DRAFT ADDENDUM TO THE FINAL EIR

FOR THE ROCK CREEK RANCH PROJECT

SEPTEMBER 2014

EXHIBIT 1: COMPARISON OF DISTURBANCE AREAS ALLOWED IN 2009 (60-LOTS) AND 2014 (10 LOTS)

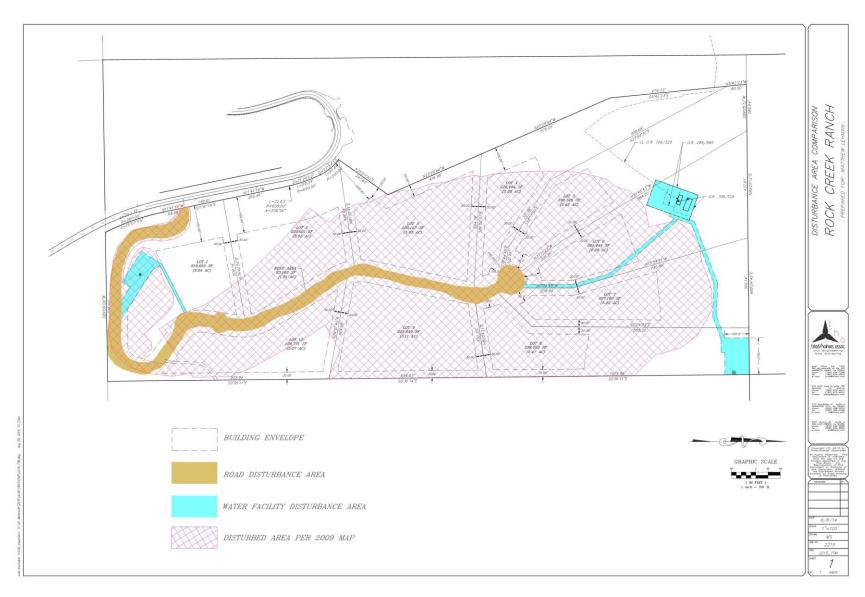
In addition to significant and unavoidable adverse impacts described above, the 2009 Final EIR also identified potentially significant impacts that would be reduced to less-than-significant levels through adopted mitigation measures. Exhibit 1 compares the disturbance areas associated with the adopted 60-lot 2009 Specific Plan to the disturbance areas associated with the 10-lot Specific Plan now under review, and Table 2 below analyzes how environmental effects associated with the proposed 10-lot plan would compare with the potentially significant impacts identified in 2009. Results of this analysis indicate that all of the potentially significant impacts identified in the 2009 Final EIR would be unchanged, reduced or eliminated if the proposed 10-lot Amendment #2 layout is approved and implemented as proposed. No new impacts have been identified, and no impacts would be increased in severity as a result of the approval and implementation of the revised Amendment #2.
